## Lewis River Fish Passage Subcommittee Meeting

**FINAL Meeting Notes  
Lewis River License Implementation  
ACC Fish Passage Subcommittee Meeting  
September 14, 2023  
2:30 PM – 4:30 PM  
MS Teams Meeting**

# Fish Passage Design Update

# Yale Barrier/Guide Net Alignment

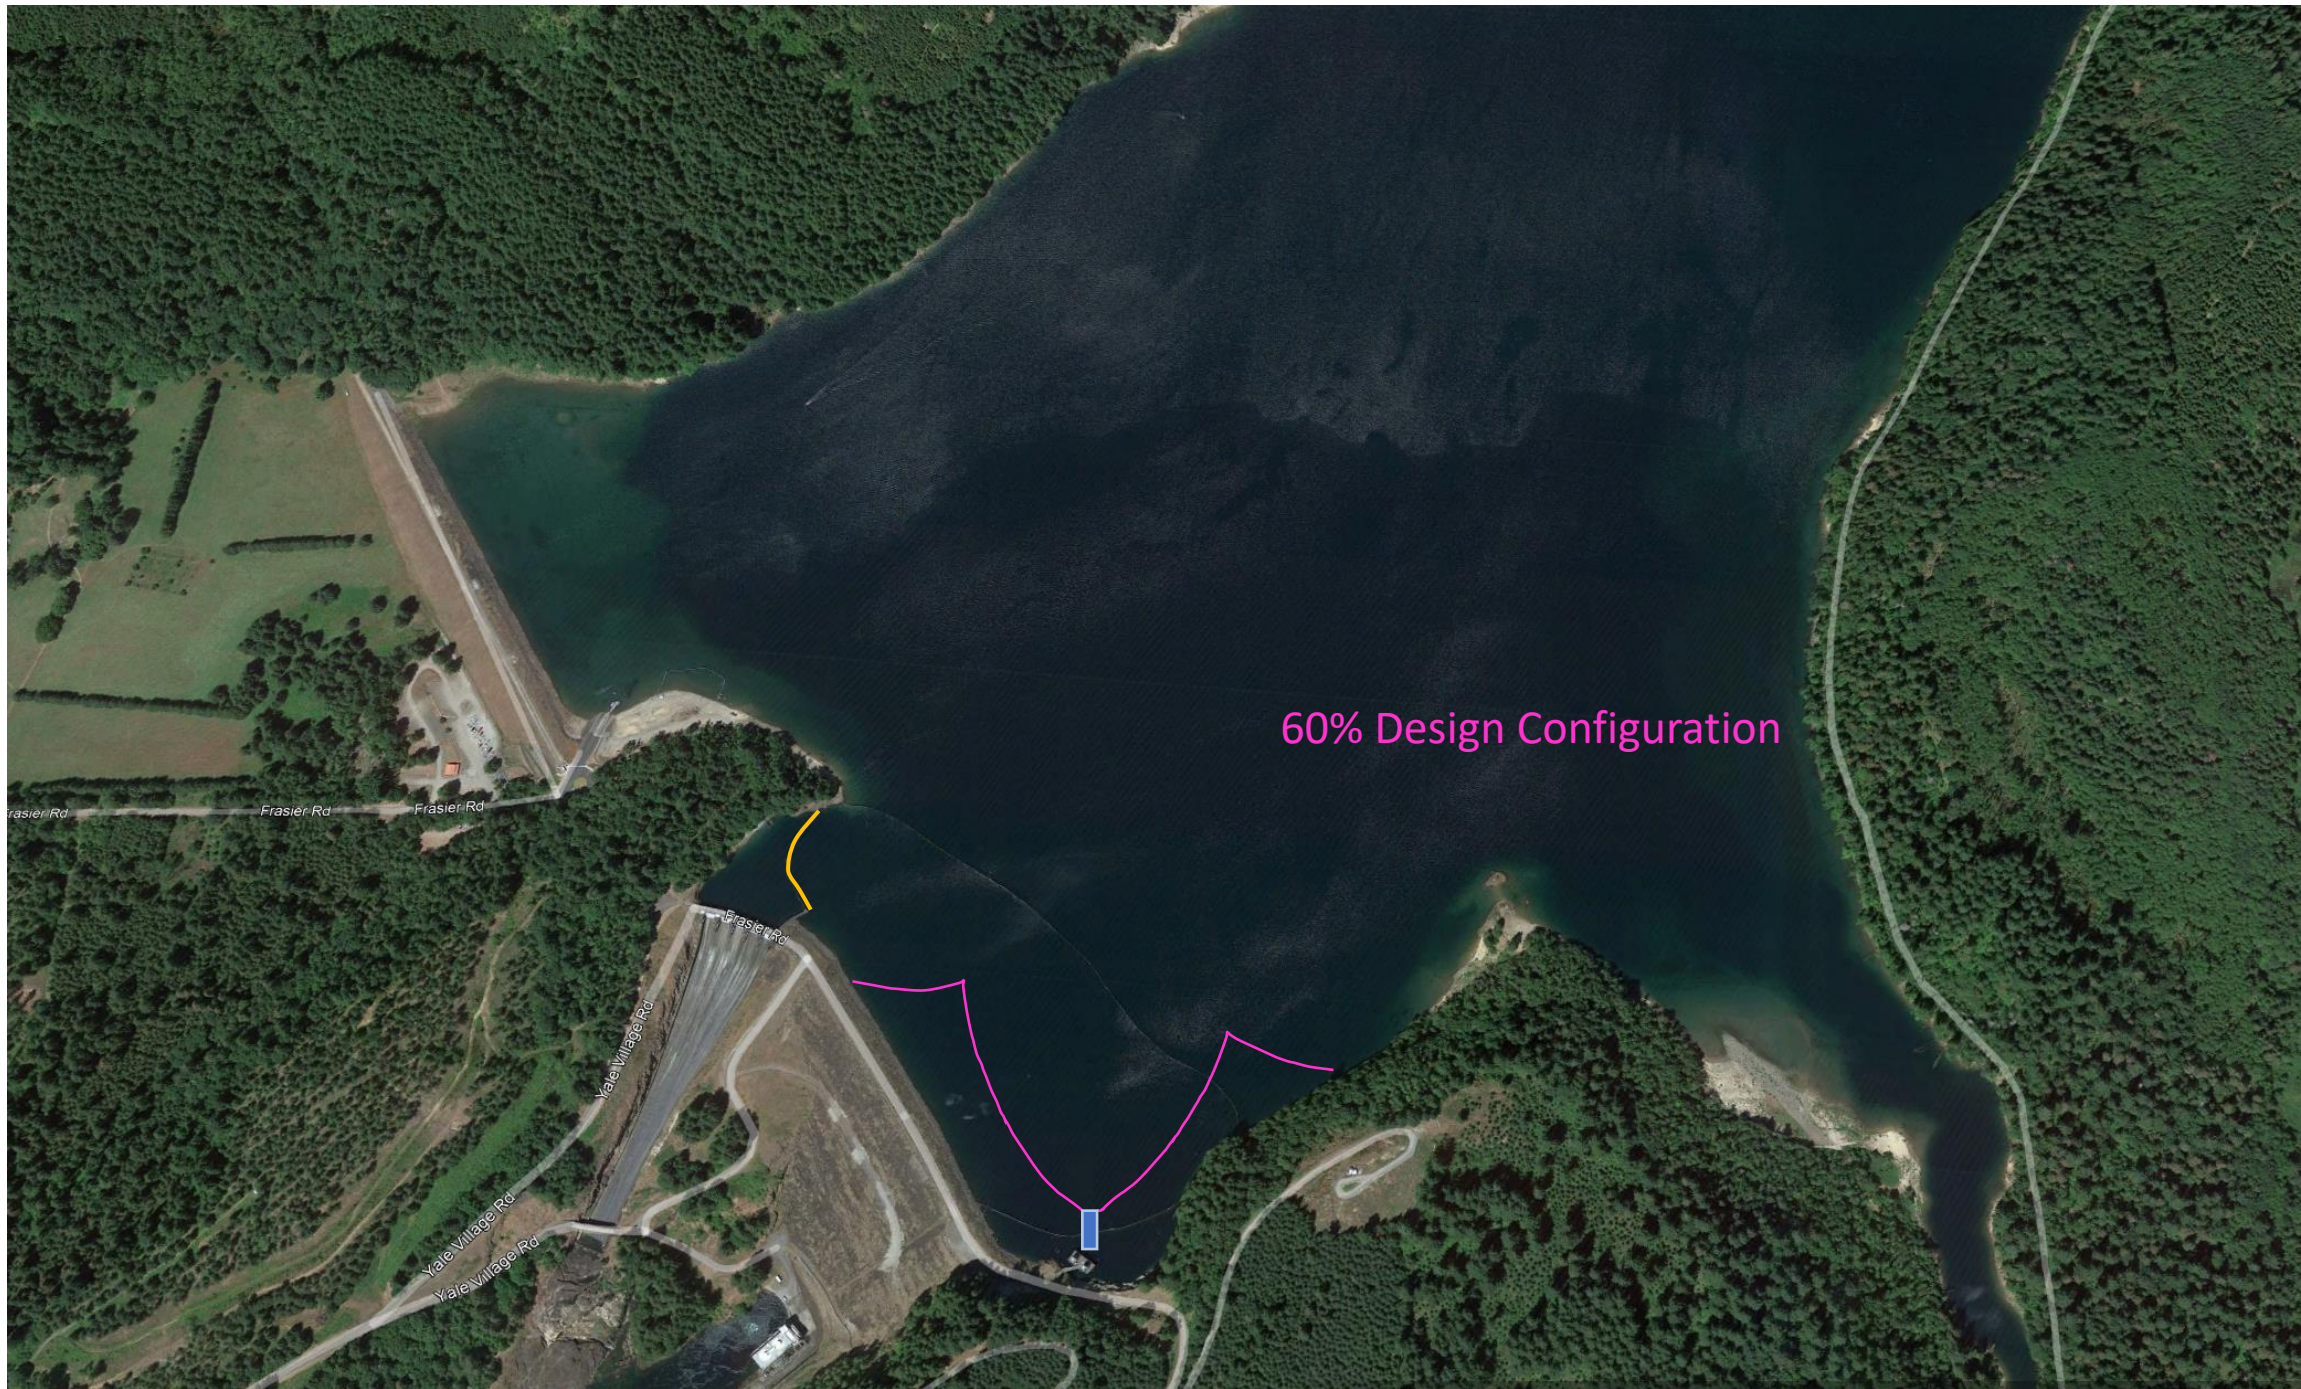
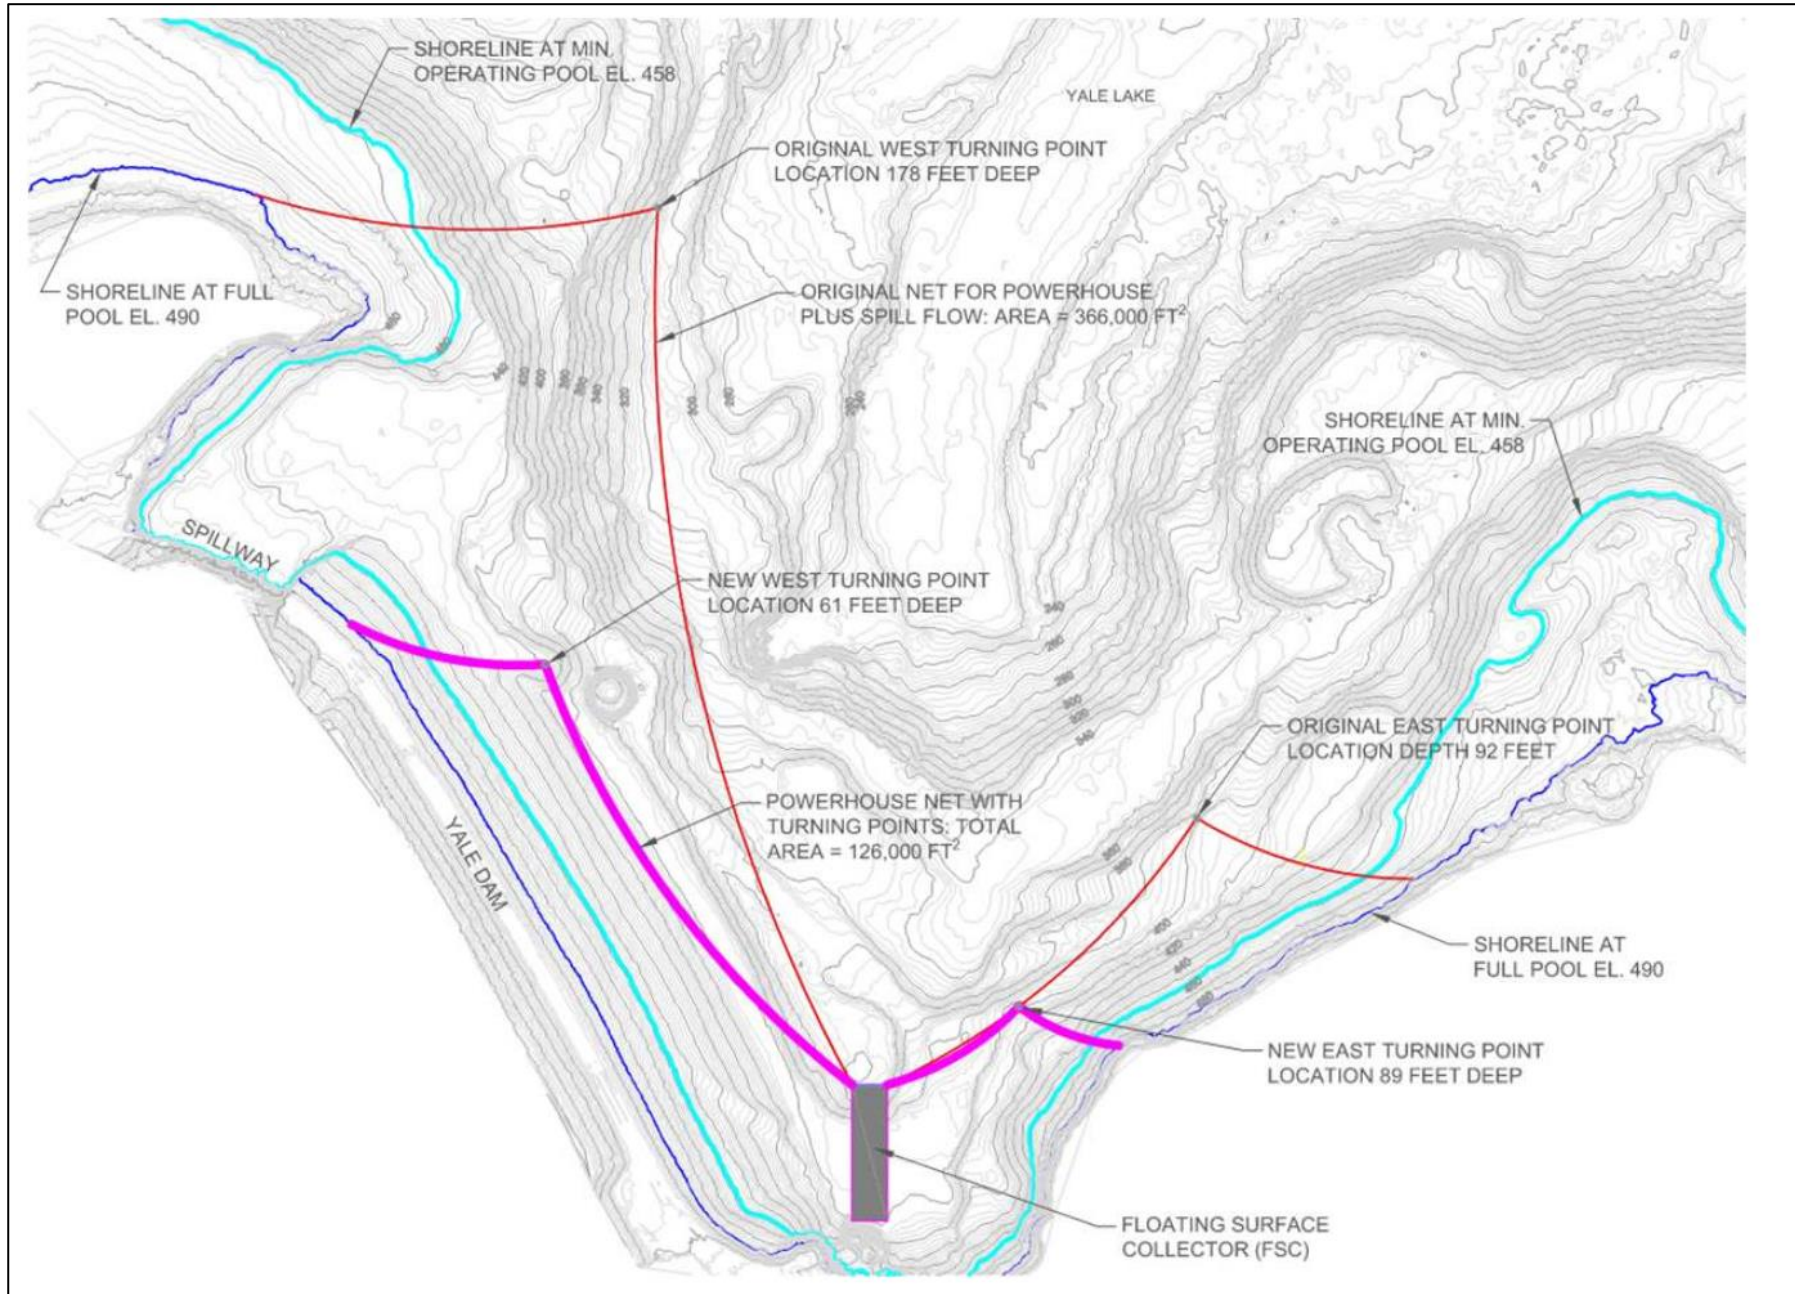
*Yale Downstream Guide/Barrier Net:* Karchesky indicated that this first change was reorientating the Yale Downstream Barrier/Guide net so that fish can use more of the natural shoreline as they enter from the west side of the forebay.

Garnett asked about the east side of the net and why it was reduced. Karchesky said it was for ease of bathymetry and is more symmetrical. We are looking at flow through velocity but it doesn't change much of the orientation. Jundt said she liked that it uses the natural bank more and feels it is an improvement. She agreed with Garnett in that they want to see the hydraulics. She asked if the existing spillway net was in good shape and what are the velocities, as well as what size was the mesh openings (because of bull trout). She doesn't want leaks that would allow small smolts to go through it. Regarding fishing mode of the net, she asked about the percentage of down mode time the spillway net currently experiences. Historic spillway operations would be helpful. Karchesky said the current net is lowered anytime spill exceeds 6,000 cfs. Miller agreed, and said she would like to see how often it would be down (10%, etc.). She is trying to channel potential comments her group would have. Karchesky said he would provide that at the October meeting. Jundt appreciated the slide presentation and said it was beneficial.

# Yale Upstream Passage

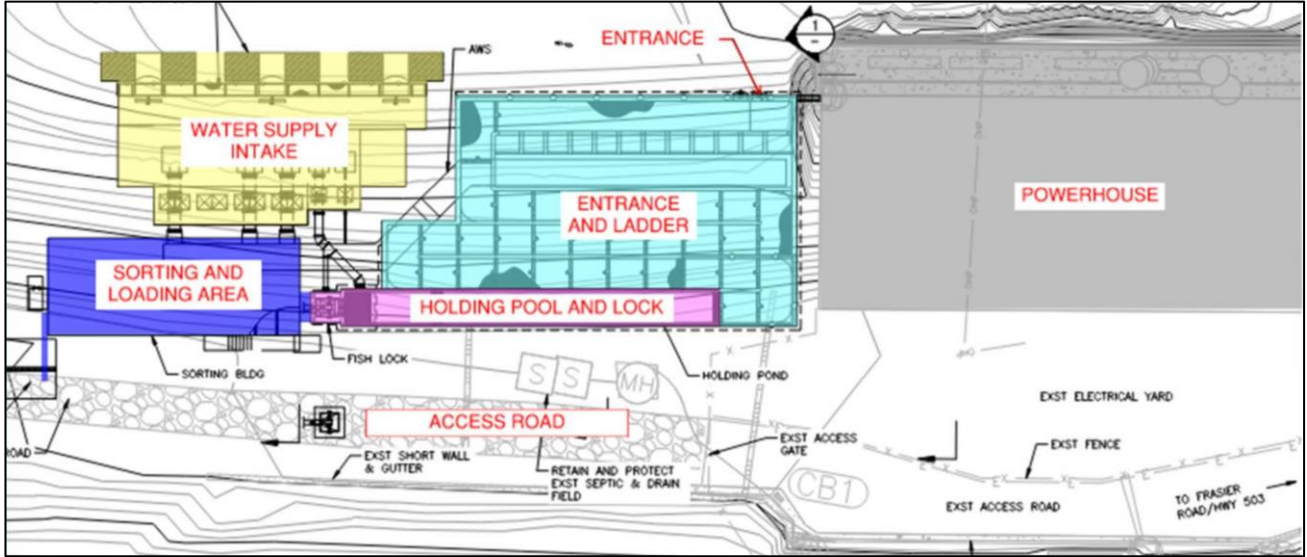
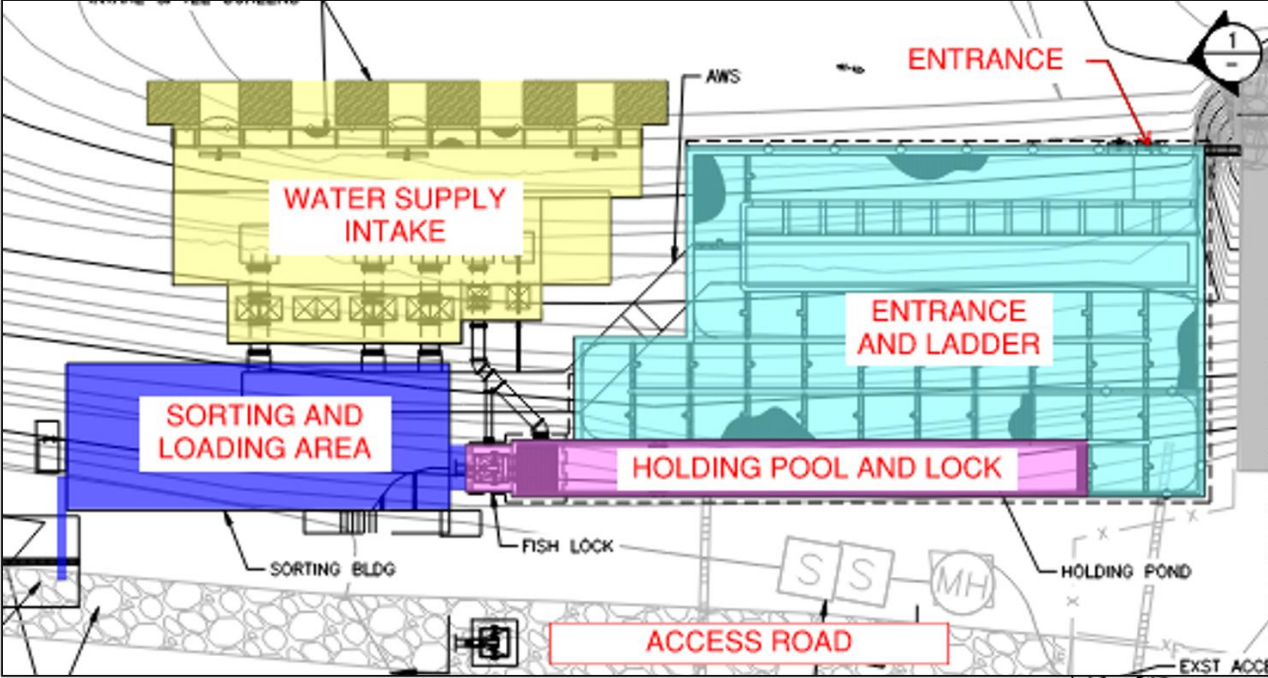
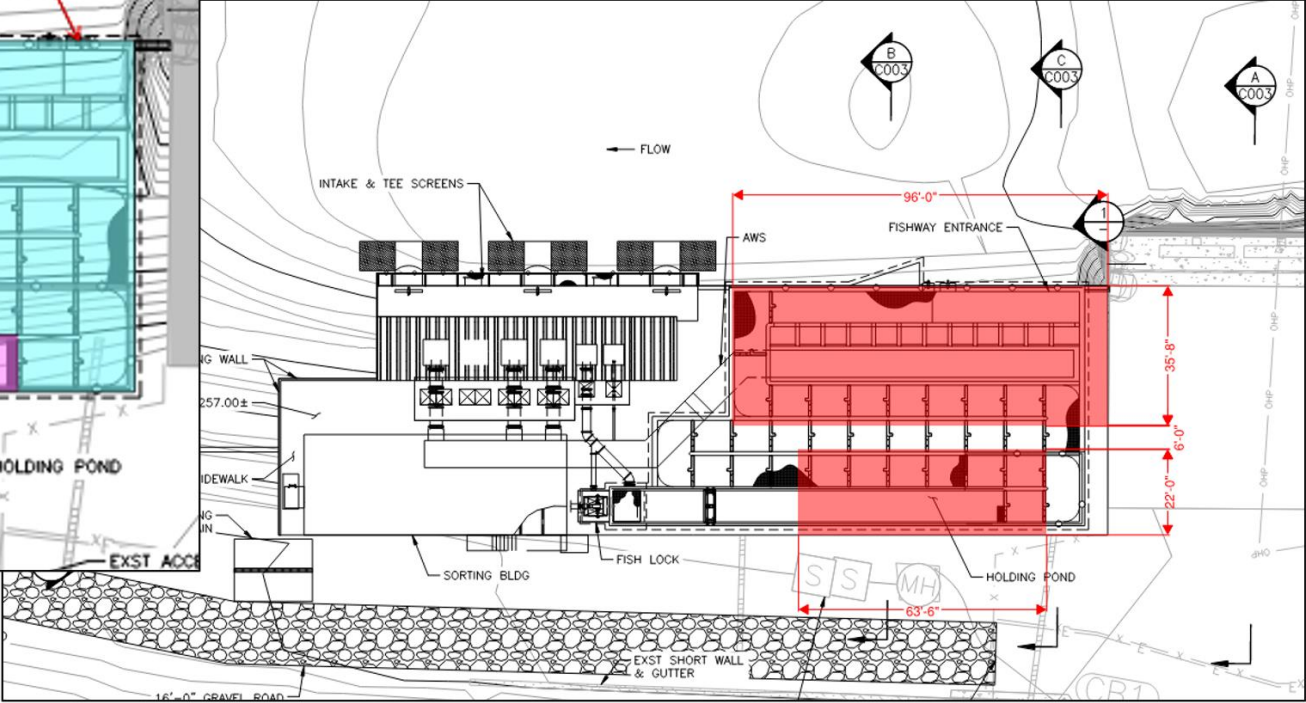
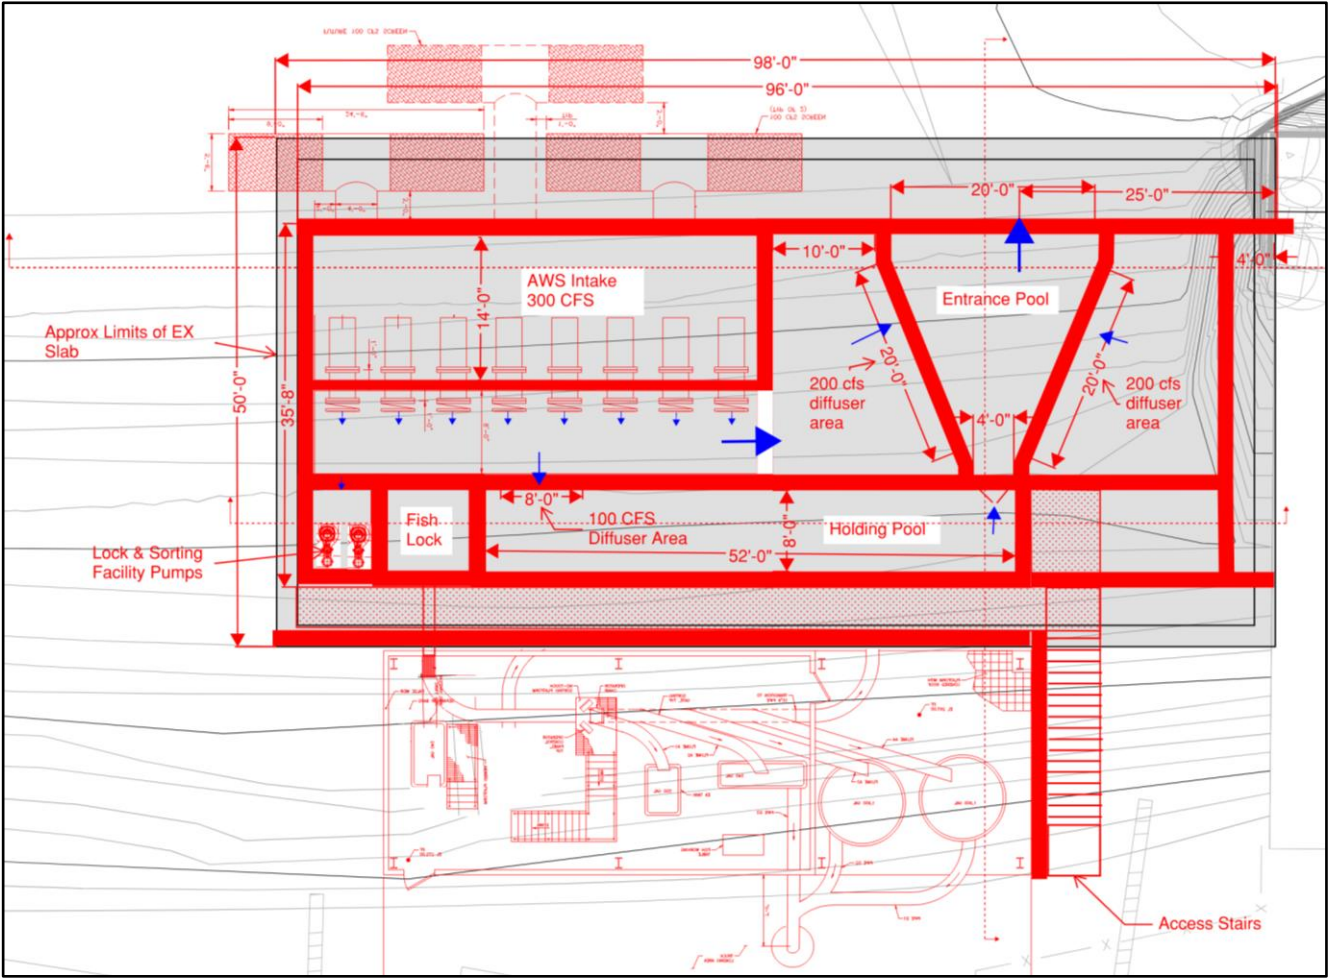
*Yale Upstream Passage Entrance Configuration:* Karchesky reminded the group that during their earlier discussion around capacity of the Yale Upstream Passage Facility, he indicated that the design team was looking at ways to make the design more efficient and lessen the need for fish to ascend such a tall fish ladder. Karchesky indicated that the design team came up with a way to put everything into a smaller footprint and not change (but in fact increase) the holding capacity. They generally designed a large, single box that houses both auxiliary water supply and the entrance pool and holding pools for fish. Jundt thinks it's a more elegant footprint. The concept is interesting and seems to fit better than the original proposal. The challenges are going to be balancing flows from one side to the other. She would like to see more details (November), but overall, she thinks it's a design improvement.

Higa added that it's lines on paper and the right angles on the paper don't show the structure geometry. The design team is still doing modelling to make sure both sides get the same amount of flow, but once built adjustments and field calibrations will be done to balance the flows out. He noted that it was similar to the Army Corps Columbia River Dam fish ladder entrance. We don't have concerns with sand or gravel as it's not a run of the river facility. Miller asked if another presentation could be given about capacity since the ladder is gone and fish can't hold there.

Garnett added that to his untrained eye, it looks like an improved design (small footprint and more efficient).
